Intracoastal Engineering PLLC

Re: Land Rover-Jaguar
PN 2015-016

Please find enclosed (4) sets of plans revised per comments. Below are our responses to each comment.

DRAWING NUMBER: **C-1** 2 OF 5

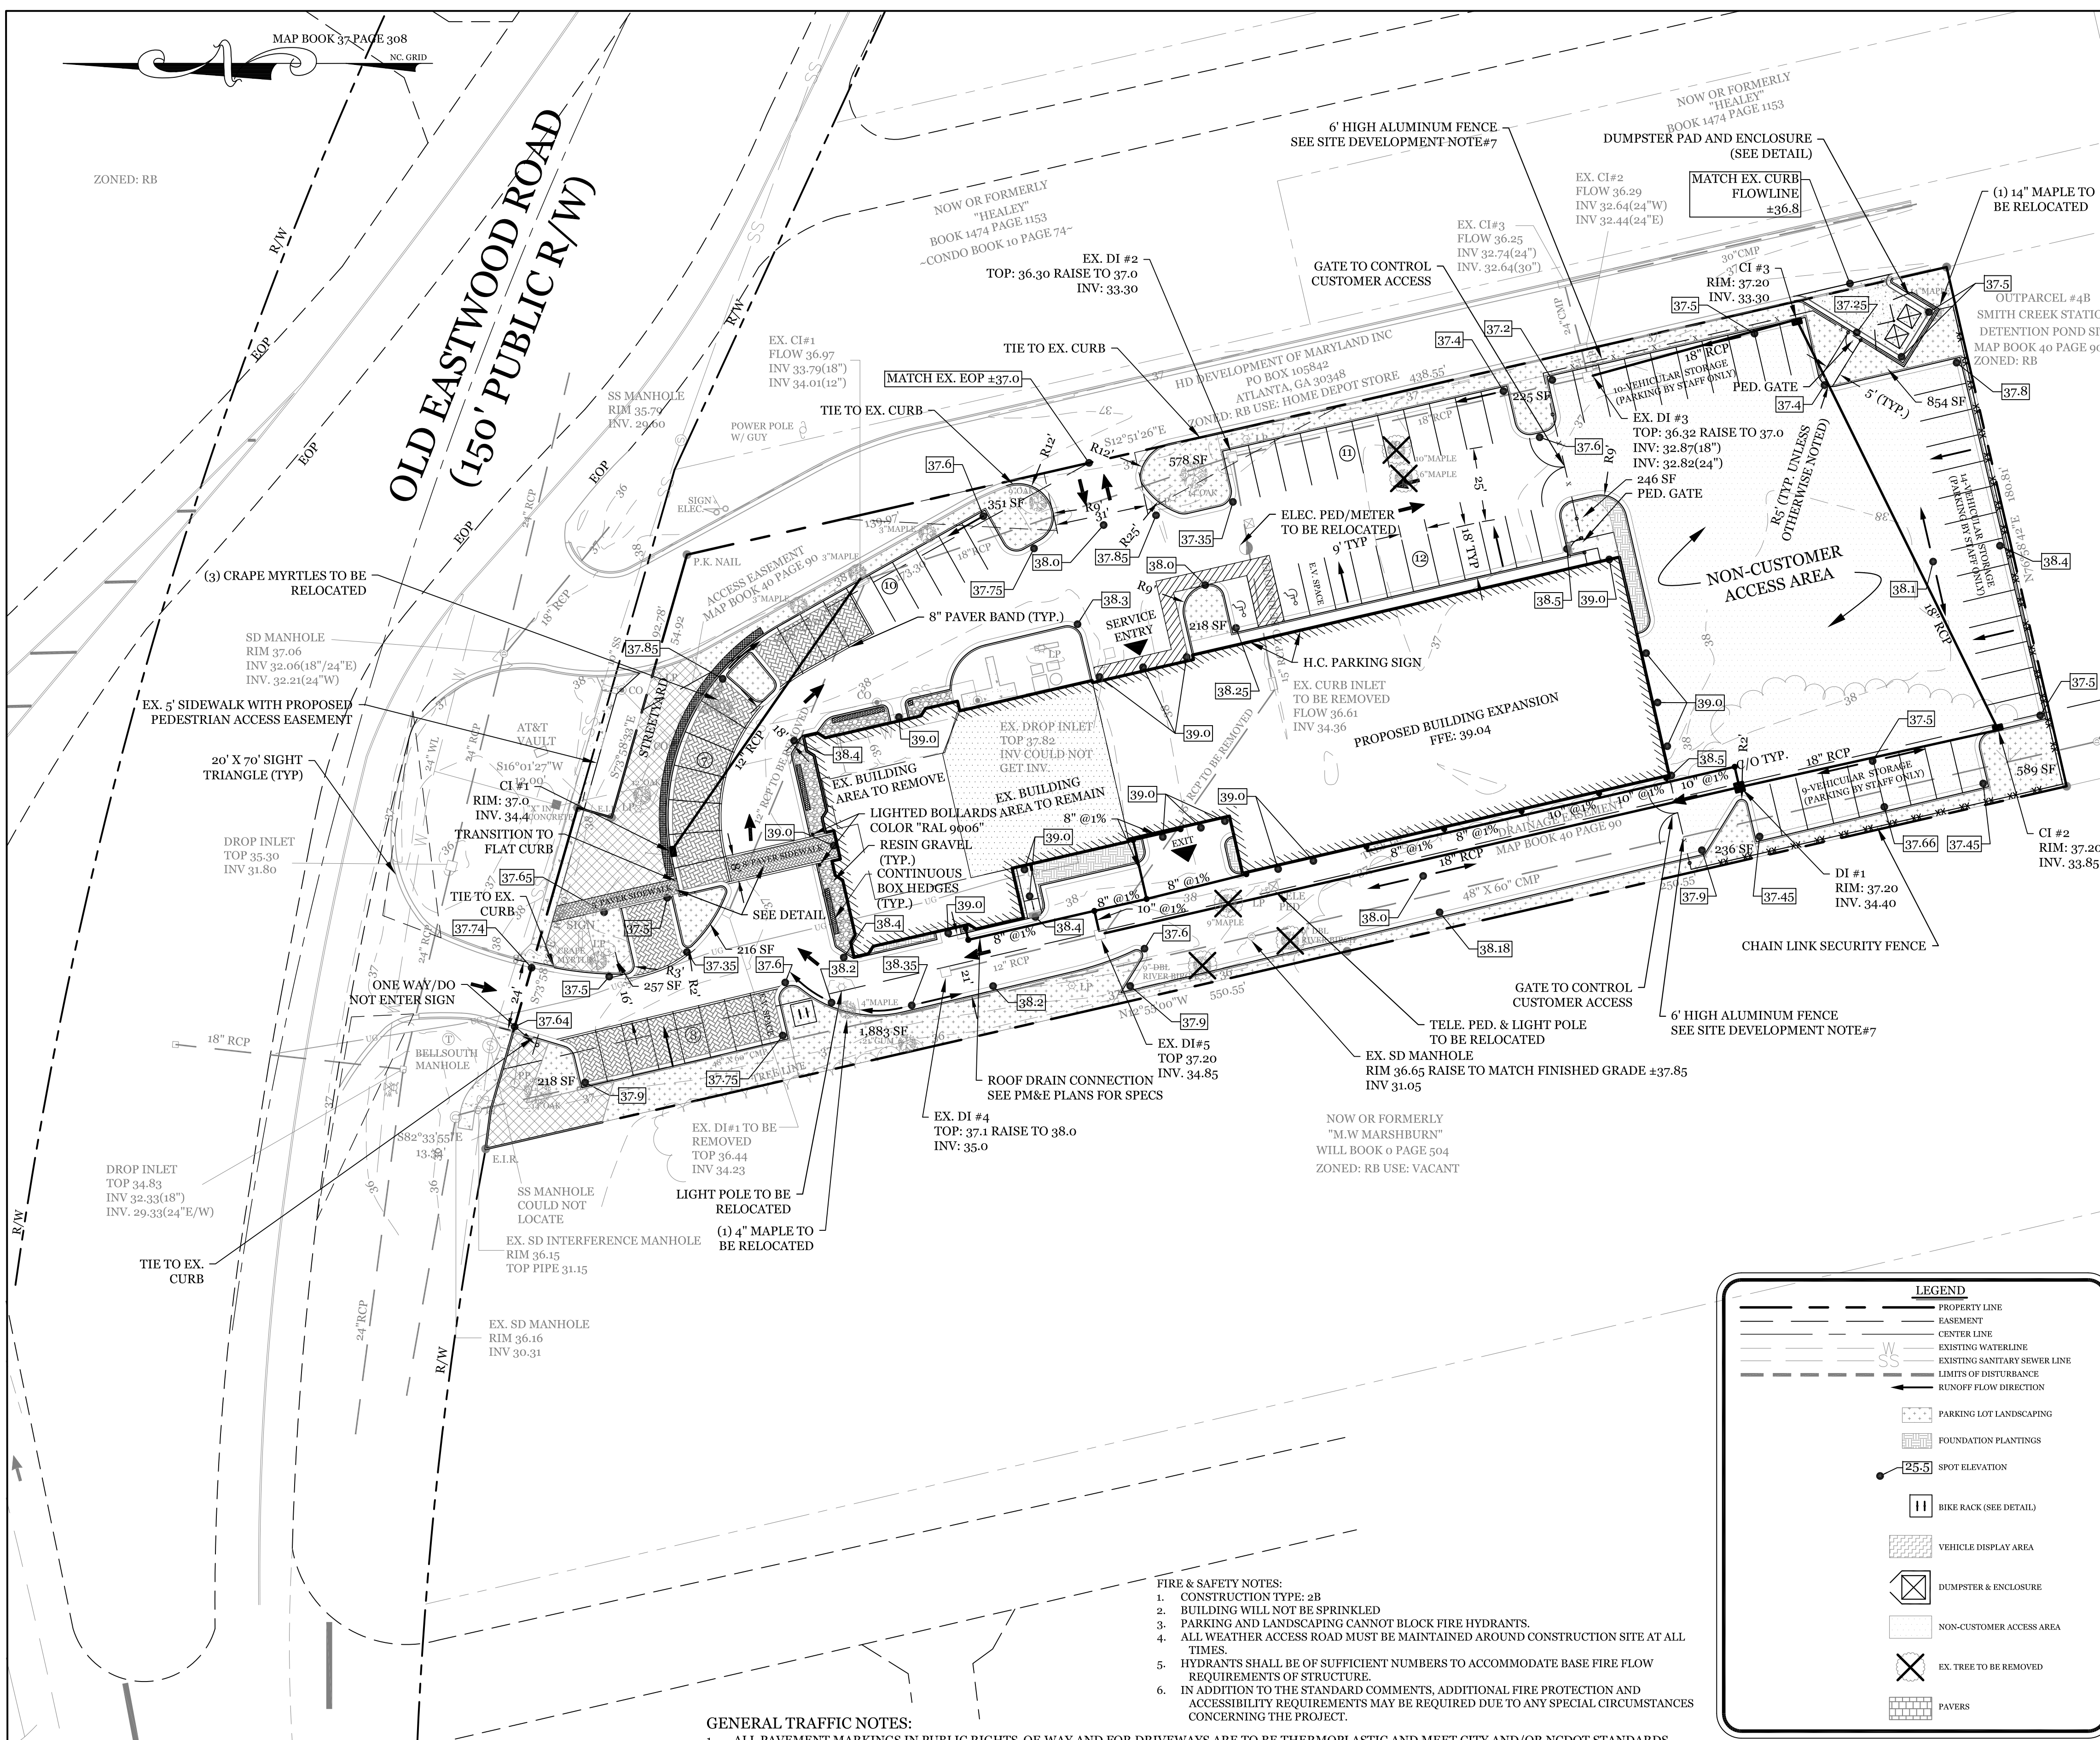
1. **Please provide signage, pavement markings and Do Not Enter signage to prevent on site exiting traffic from going out the one way entrance. [7-9 CofW Tech Stds]**
Pavement markings and a "One Way/Do Not Enter" sign are now shown.
2. **The site does not appear to have internal sidewalk adjacent to the building or handicap parking spaces. If internal sidewalk is present, please show dimensions for the existing and proposed sidewalks. *We have added dimension for internal sidewalks as well as a detail.***
3. **Provide a sidewalk connection between the site and the public sidewalk.**
A pedestrian connection is shown from the R/W to the building.

6. **Please label the radius on the landscape islands. [Chapter VII, Detail SD 15-13 CofWTSSM]**
We have labeled the landscape island radii.

7. Please ensure the two parking space at the northeastern portion of the building can back out without striking the building corner. *While we acknowledge that this area of the site is tight, we feel there is enough room for vehicles to maneuver and given the site constraints, we do not see a viable way to increase space in that area.*

1. The ADA path is required to go from the ADA parking spaces to the building. The Handicap Accessible Path from the Handicap Accessible Parking Spaces appears to end at the Service Entry doors, which is typically not a regular customer entrance. *The service entry bay is a customer entrance and has direct access to the Showroom. This is the most practical path for someone to take. The alternative would be an unnecessarily long path all the way around the building to the front. We feel the H.C. parking location and walking path is the most reasonable location to provide access to both the service area as well as the Showroom.*
2. Please clarify where the ADA Accessible Path enters the building/show room. *The service entry bay is a customer entrance and has direct access to the Showroom.*

I have yet to see Chief Sammy Flowers (my predecessor) comments for version 1 addressed on the plans "..... If the new construction is all classified as a repair garage, it will be a Group S-1 Storage occupancy. Being an S-1 over 12,000 square feet, fire sprinkler protection is required.

However, if the intent is to separate the interior space to reduce the square footage of the repair garage to less than 12,000 sf, there will not be a fire sprinkler requirement."

If the building will not be separated or compartmentalized by the appropriate fire rated separation and an automatic sprinkler system will be used then the following comments need to be addressed or added to the plans:

The building will not be sprinkled. Per the Architect, the building Type is 2B and is classified as "non-separated mixed use."

We have added applicable fire / safety notes to the plan.

DRAWN: JAE SHEET SIZE: 24 X 36
 CHECKED: CDC DATE: 3/21/2017
 APPROVED: CDC SCALE: 1" = 30'
 PROJECT NUMBER: 2015-016
 DRAWING NUMBER: **L-1**

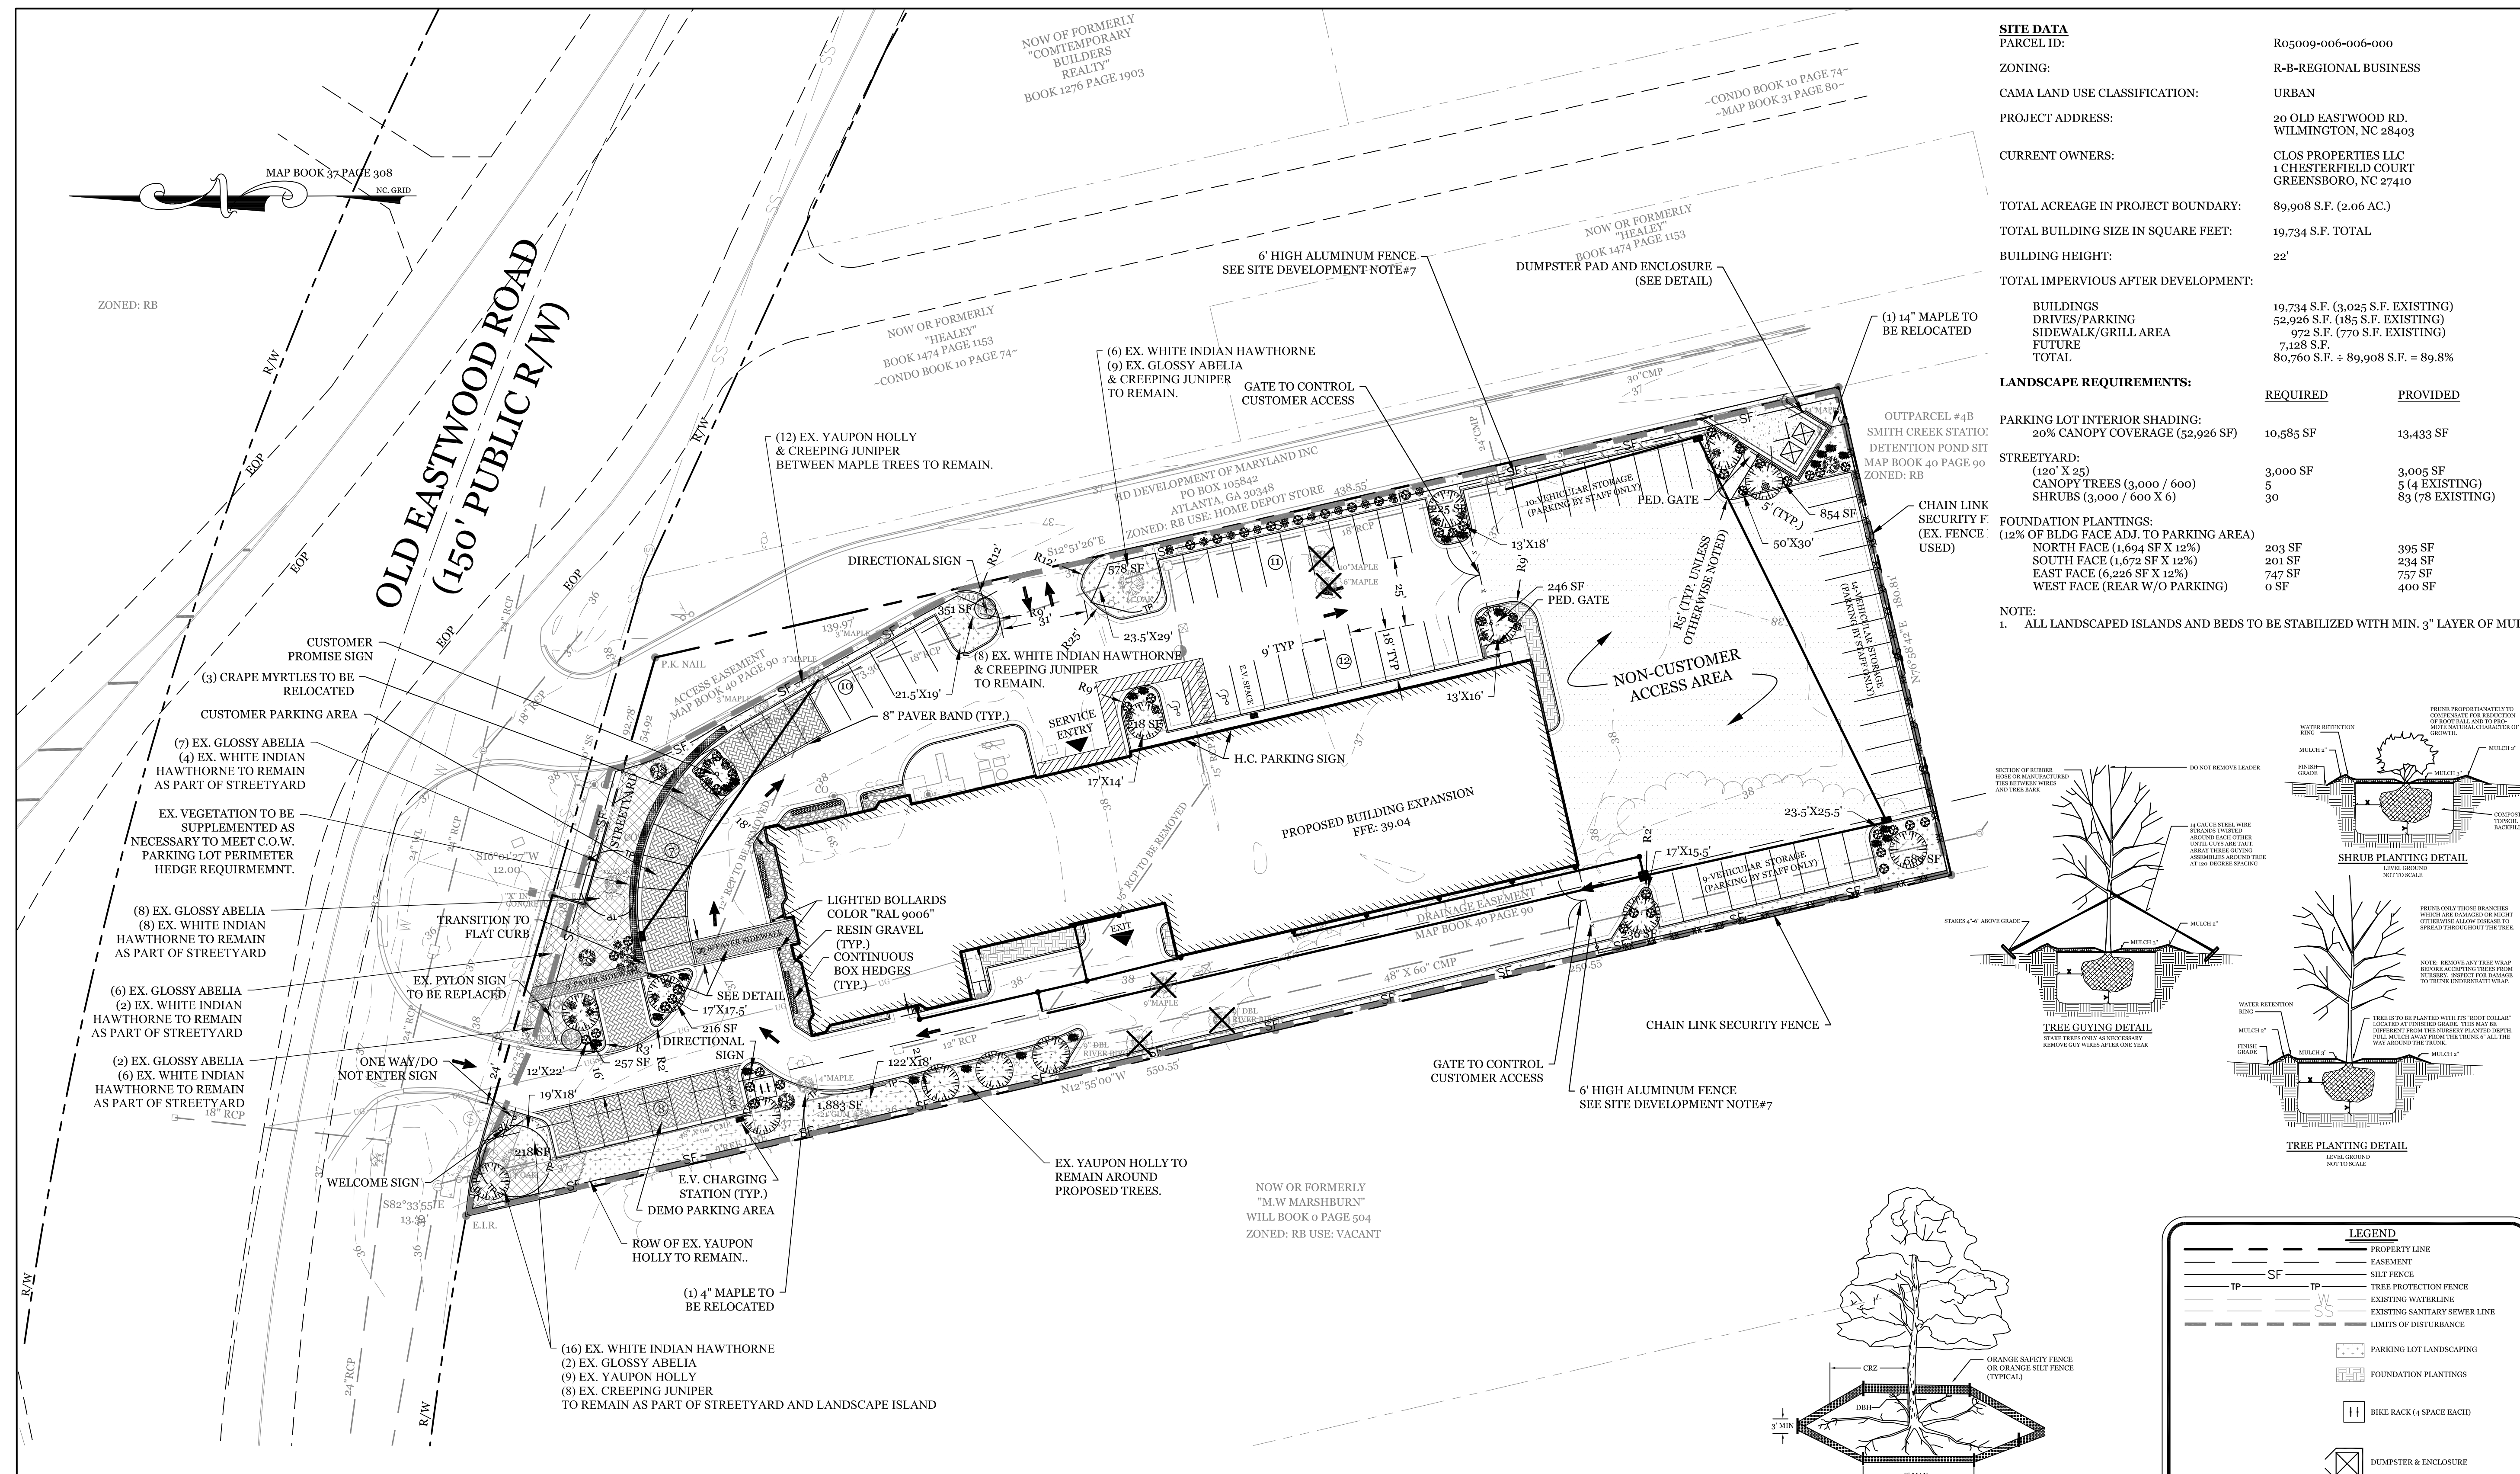
- Crepemyrtle is not a large shade tree. Please choose an appropriate large-maturing shade tree. *We have replaced the Crepe Myrtles with Live Oaks.*

- **Sec. 18-60 (c) (15): Show a proposed landscape plan.**
 - **Dimension landscape islands, several do not meet the minimum required.**
 - **Can you just label them in tags on the landscape plan? I need to confirm all sizes and I can't do that with the way it's drawn currently.**

- **Landscape islands are independent of streetyard. Please show streetyard compliance once the landscape islands are removed from the calculations**

- **Since parking faces a right-of-way a low buffer of shrubs at least 3 foot tall is required. Please add to the landscape plans.**
 - **I need the type shrub being used and show height in planting list.**

Landscape island dimensions are now shown on the landscape plan.

We have revised the plan to meet both streetyard and parking lot interior landscaping requirements.

We have included the type of shrub to be used to supplement the existing shrubs to meet this requirement.
